## **Committee of Experts on the Transport of Dangerous Goods and on the Globally Harmonized System of Classification and Labelling of Chemicals**

**Sub-Committee of Experts on the Transport of Dangerous Goods**

## **Manual of Tests and Criteria**

### **Review of Test Series 8**

Figure 18.5.1.1: ANE GAP TEST

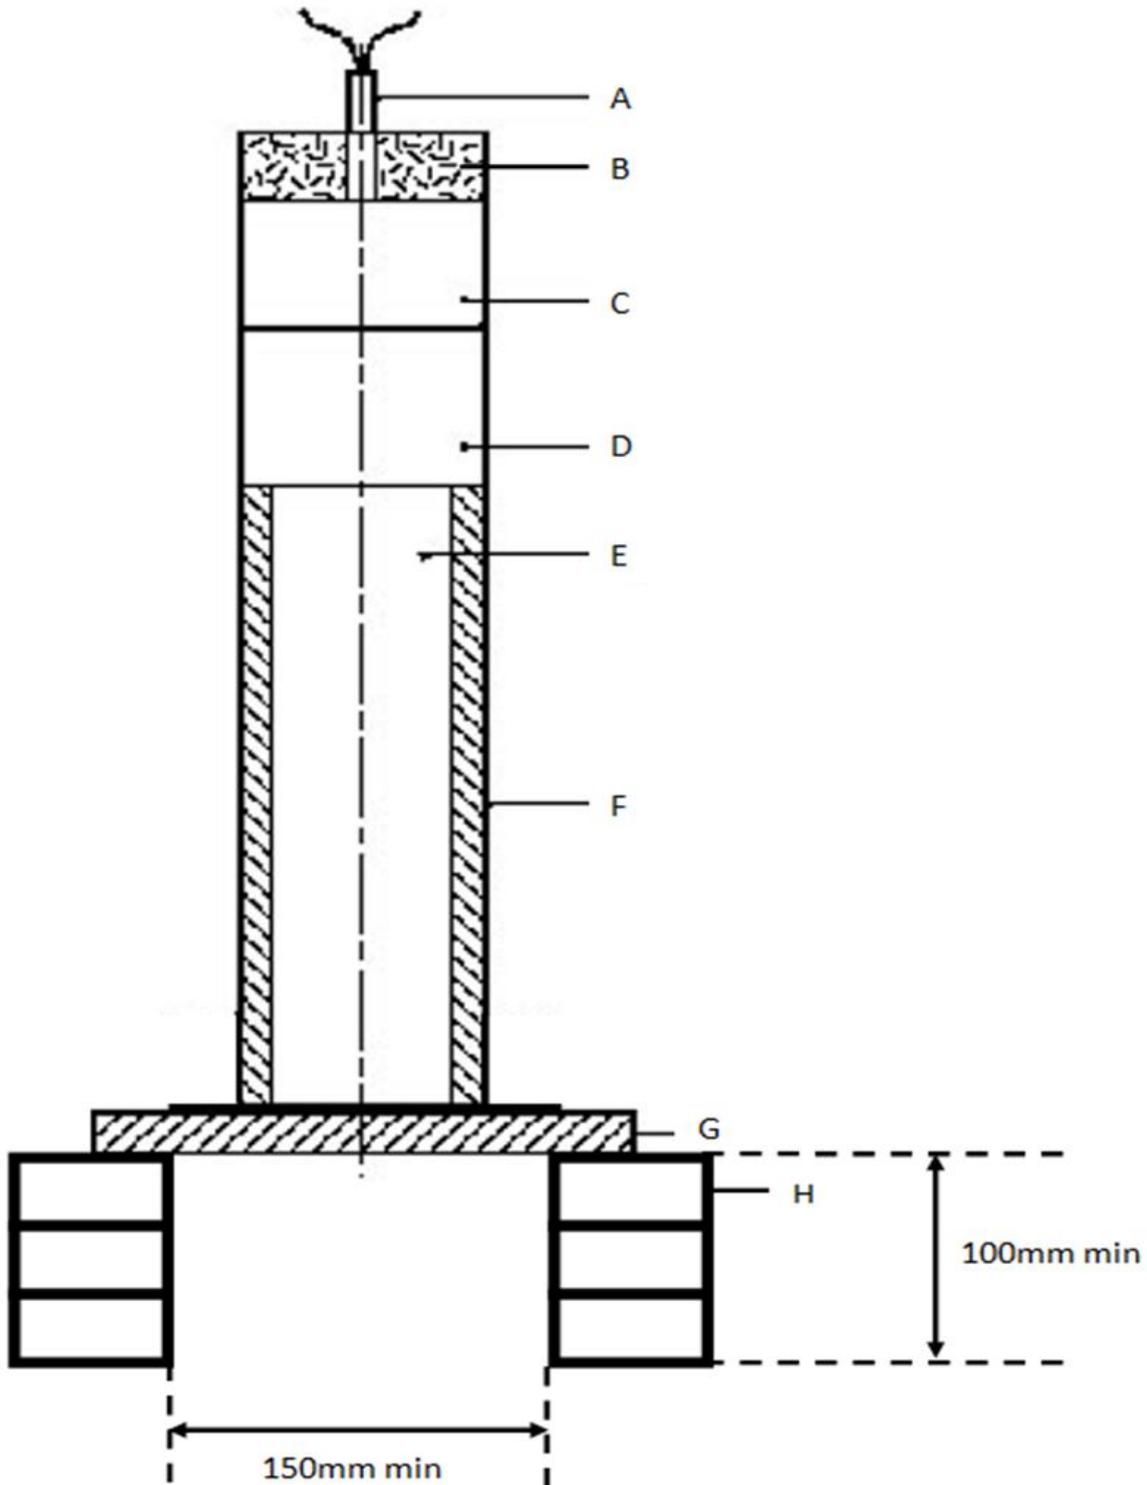
- changes agreed at 41st session have been included;
- the 'seamless' specification for the steel tubing has been removed as this is considered an over-specification for what is a sensitivity test (ie fragmentation of tubing not an issue here);
- reference to 'UN standard detonator' amended;
- reference to conducting test over container of water removed (over specified) and replaced with the witness test plate needing to be off the ground (100 mm);
- calibration data removed (Table 18.5.1.1 and Figure 18.5.1.2) as not relevant here (could be captured in the Appendices if considered useful);
- Figure 18.5.1.1 amended to reflect test set up.

18.5.1.3.1 As shown in Figure 18.5.1.1, the detonator, booster charge, PMMA gap and acceptor charge are coaxially aligned above the centre of the witness plate.

only with wooden blocks, or similar, as shown in Figure 18.5.1.1. The location of the blocks must ensure that there is a clear space under where the tube is standing on the witness plate. To assist in collecting the remains of the witness plate, the whole assembly should be vertical (e.g. checked with a spirit level).

Figure 18.6.1.3 EXAMPLES OF EFFECT TYPES D, E AND F

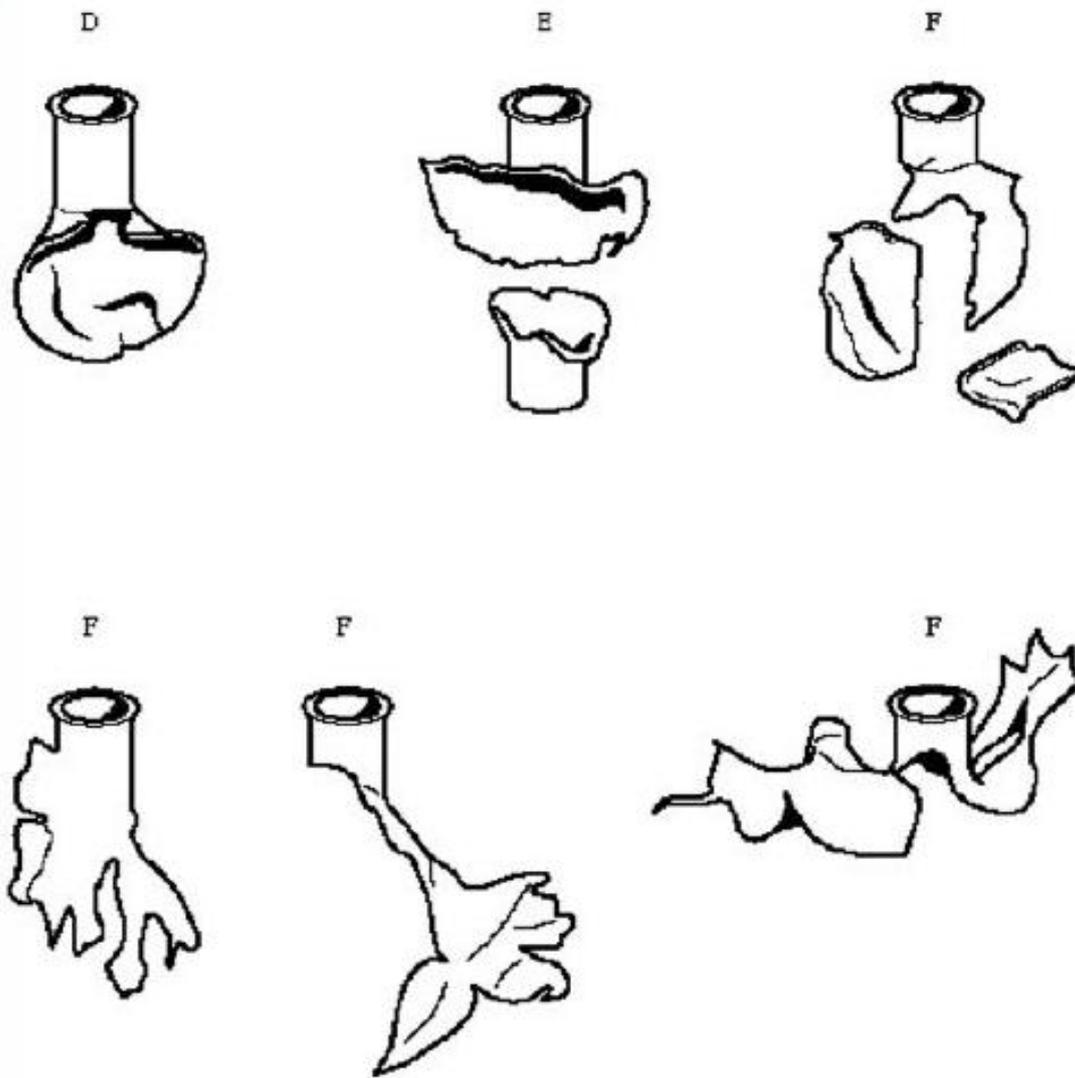
- written as a go/no go test using a 2.0 mm orifice plate (ie removing all other orifice plates, other than the 1.5 mm calibration orifice plate);
- molybdenum disulphide used as one example of a high temperature anti-seize compound;
- pictures of equipment added;
- pictures of resultant effects added;
- source of supply of tubes included;
- criteria allowance for 'false positives' from orifice blockages.

Examples for the effect types "D", "E" and "F" are shown in Figure 18.6.1.3. If a trial results in any of the effects "O" to "E", the result is regarded as "no explosion". If a trial gives the effect "F", "G" or "H", the result is evaluated as "explosion".
